HISTORIC AND DESIGN REVIEW COMMISSION

HDRC CASE NO: 2016-361
COMMON NAME: 1441 SE MILITARY DR
LEGAL DESCRIPTION: NCB 7657 BLK LOT W IRR 447.39 FT OF P
ZONING: C3NA H RIO-5
CITY COUNCIL DIST.: 3
DISTRICT: Mission Historic District
APPLICANT: Jason Fuego/MDN Architects, Inc.
OWNER: Security Service Federal Credit Union
TYPE OF WORK: Installation of an ATM and ATM canopy

REQUEST:

The applicant is requesting a Certificate of Appropriateness for approval to install an ATM canopy and ATM shelter at 1441 SE Military, the location of new construction, previously approved by the Historic and Design Review Commission.

REMOTE ATM CANOPY
WITH SIGNAGE

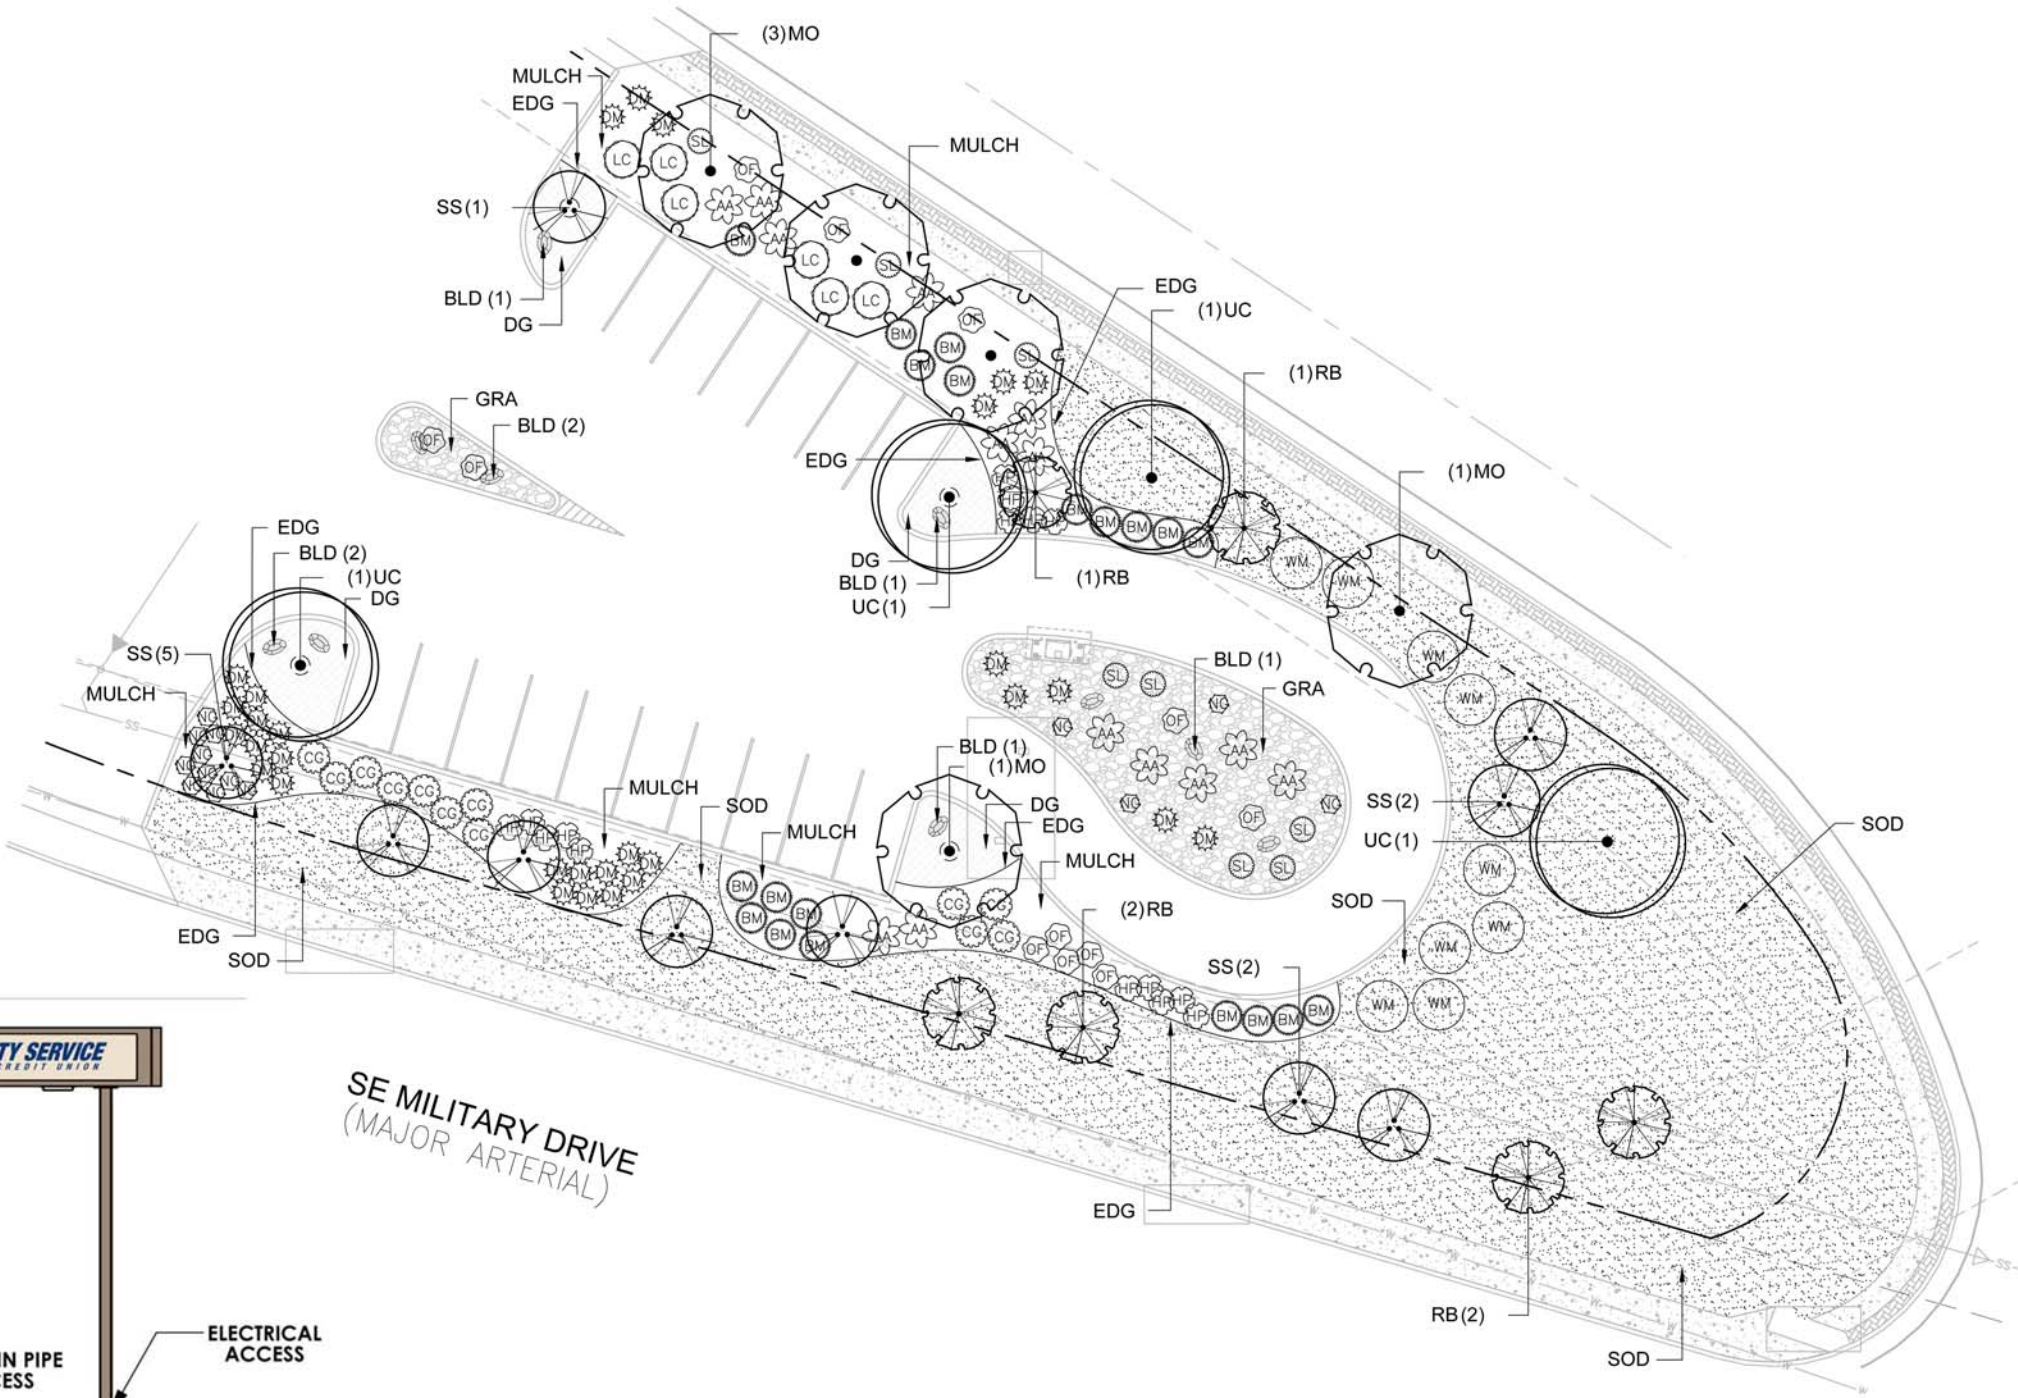
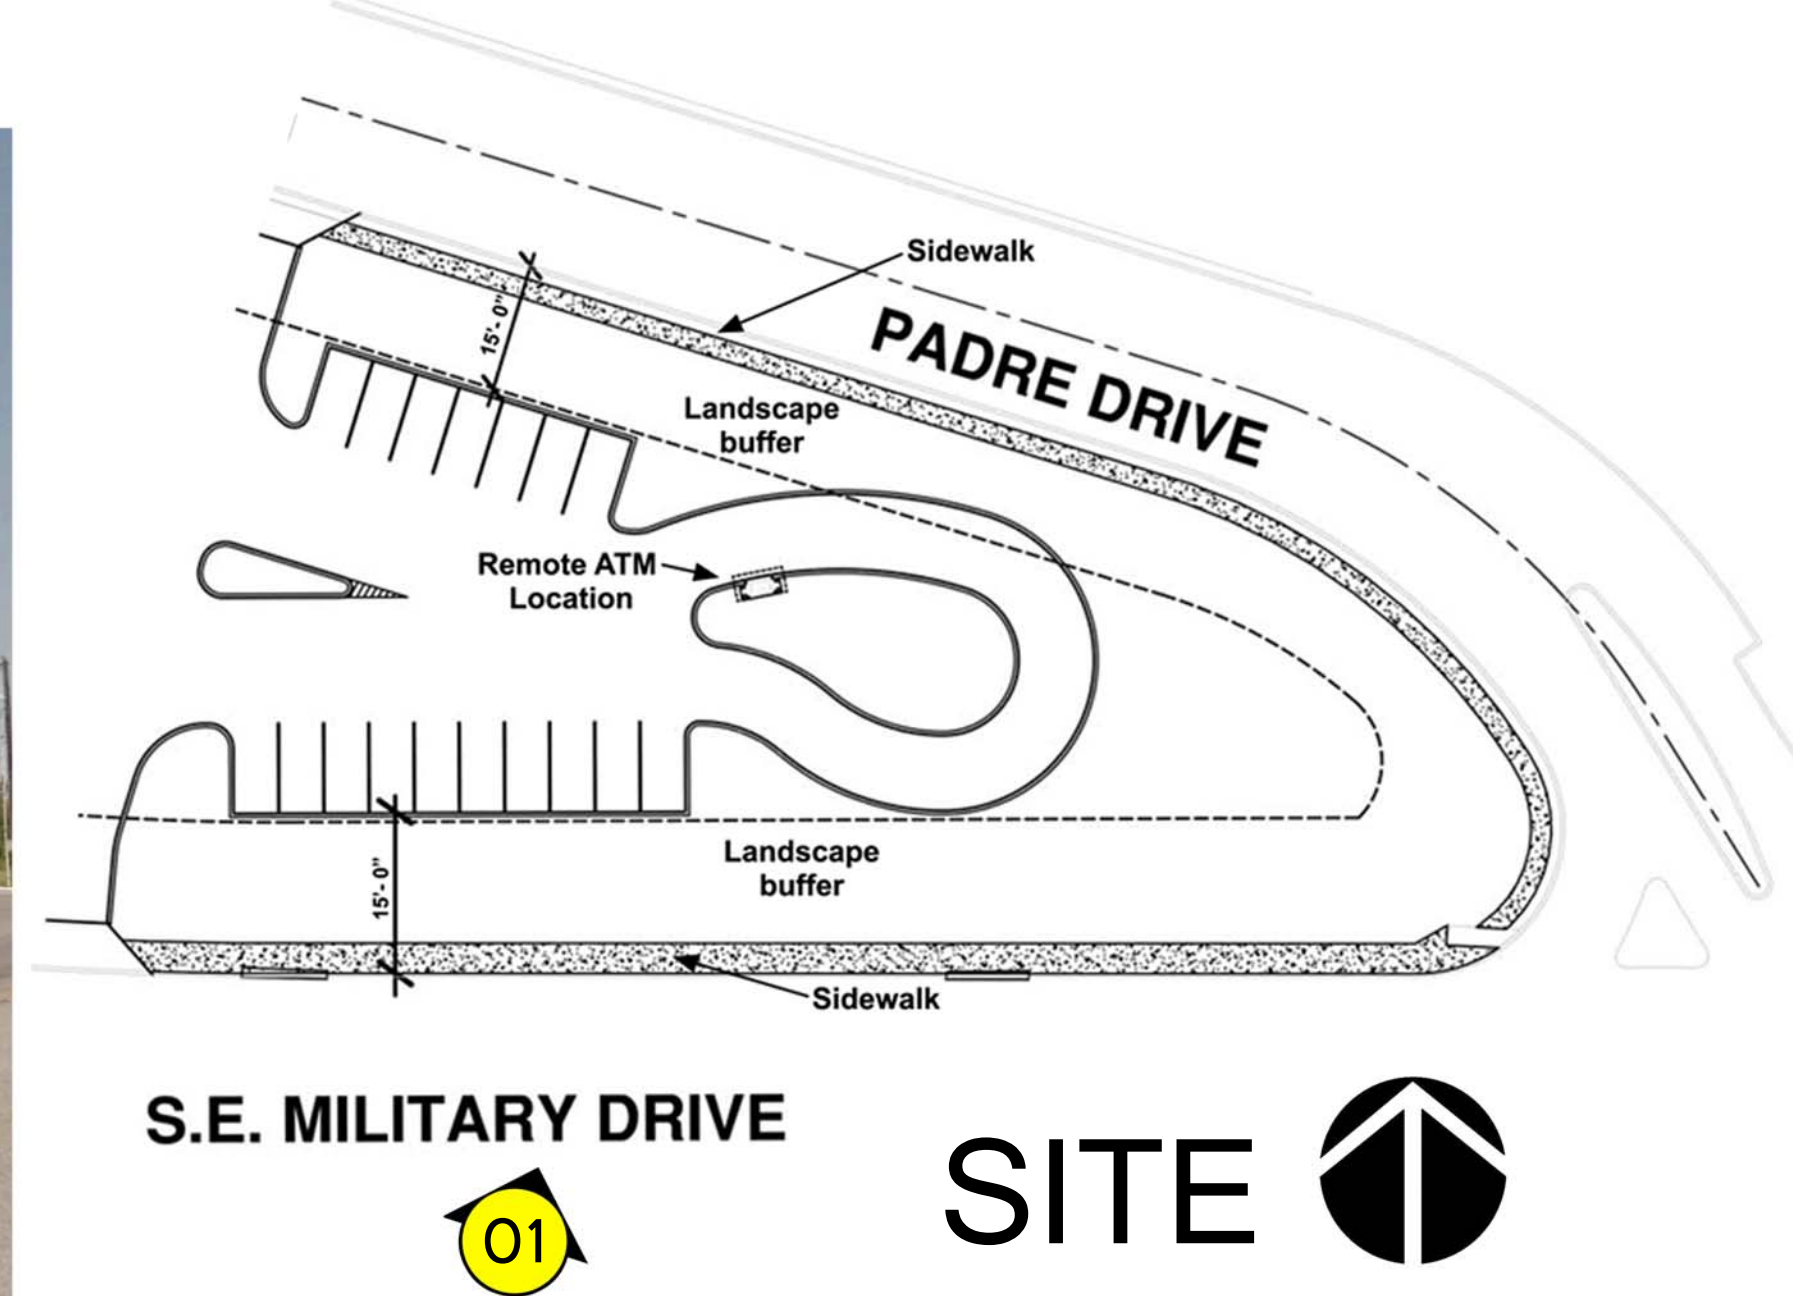
- c. At this time, the applicant has proposed to install the eastern ATM and ATM shelter in its original location. The applicant has proposed to install the ATM on a landscaped island to be surrounded by a number of landscaping materials including agave, Mexican bush sage, spineless Texas prickly pear, new gold lantana among others.

- d. While the installation of landscaping buffers and plant materials to screen the ATM will reduce its visual impact, staff finds that the ATM's installation would reduce the overall amount of naturally landscaped area. Staff maintains the finding that the elimination of the additional ATM would facilitate the increase of naturally landscaped areas.

Staff does not recommend approval based on findings a through d.
